#### Regulation No. 10 (Electromagnetic compatibility)

### **Proposal for the 04 series of amendments to Regulation No. 10**

#### **Submitted by the experts from France and Germany\***

**“Figure 3**  
**Vehicle in configuration “RESS charging mode” coupled to the power grid Elevation**

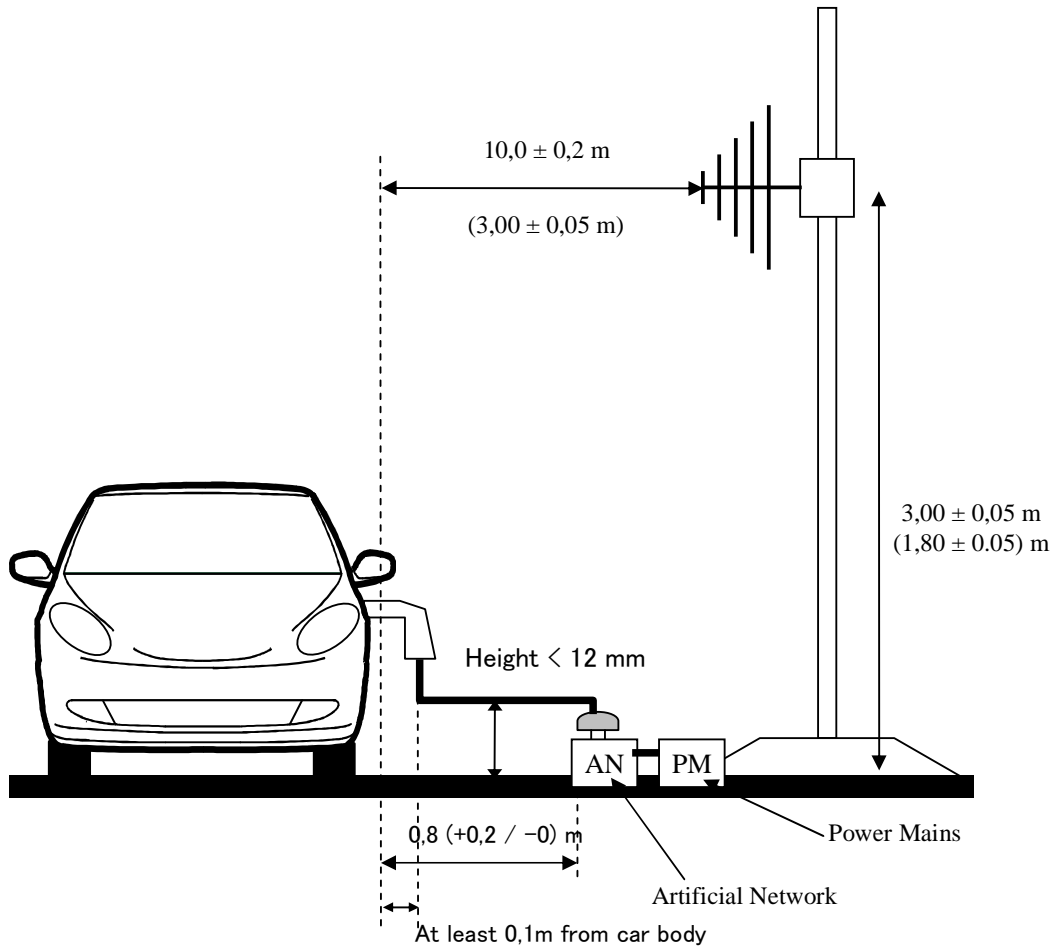
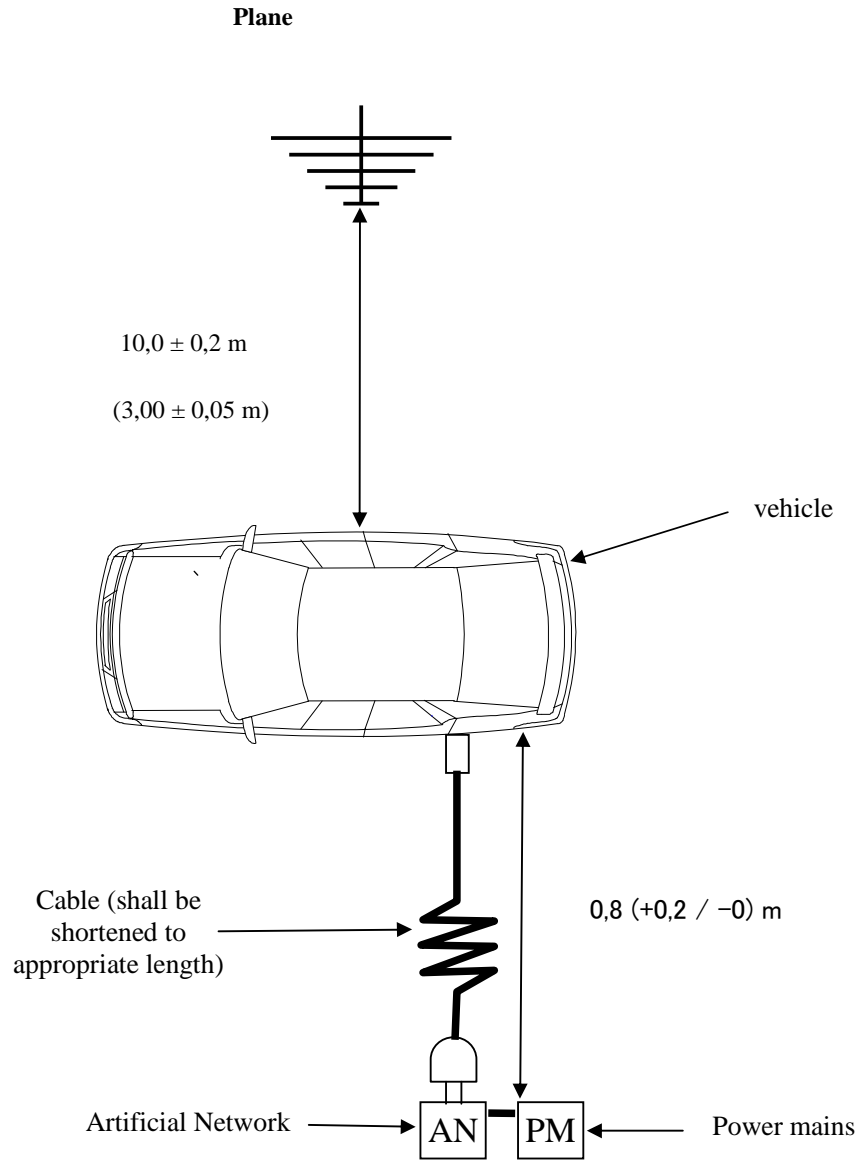
- “2.2. **Vehicle in configuration “RESS in charging mode coupled to the power grid.**
- This vehicle shall be in battery charging mode at rated power until the AC or DC current reached at least 80 per cent of its initial value. The test set-up for the connection of the vehicle in configuration “RESS in charging mode coupled to the power grid” is shown in figure 3 of Appendix 1 to this annex.”**

Insert new figure 3, to read:

**“Figure 4  
Vehicle in configuration “RESS in charging mode coupled to the power grid”**

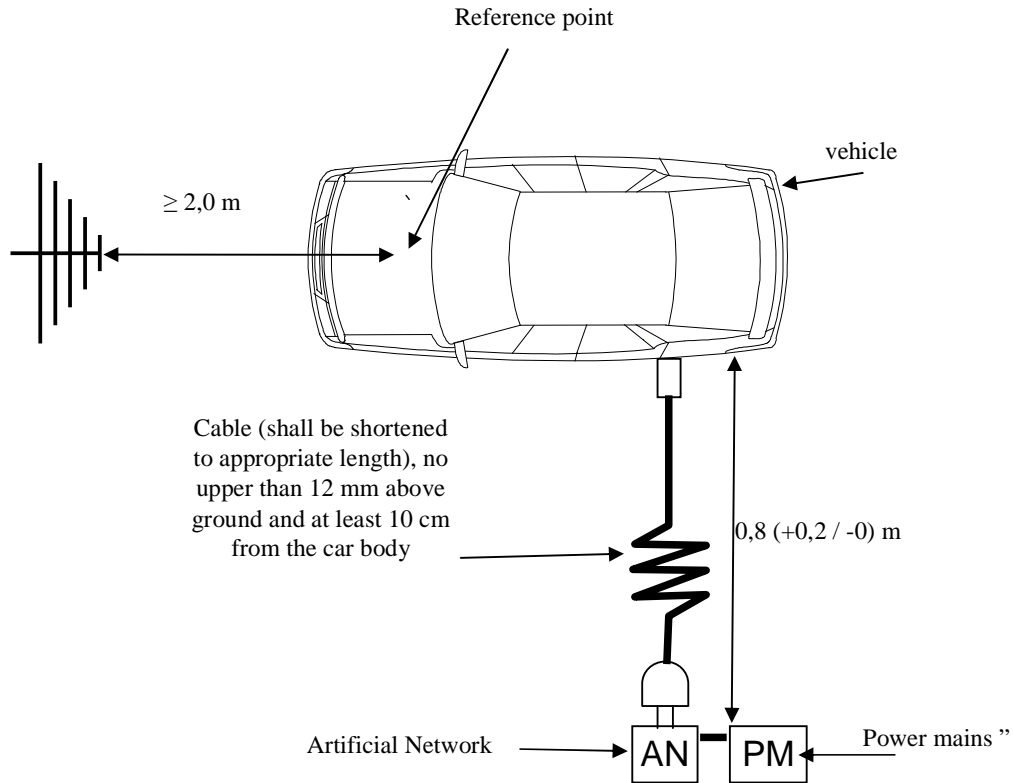
Insert new figure 4, to read:
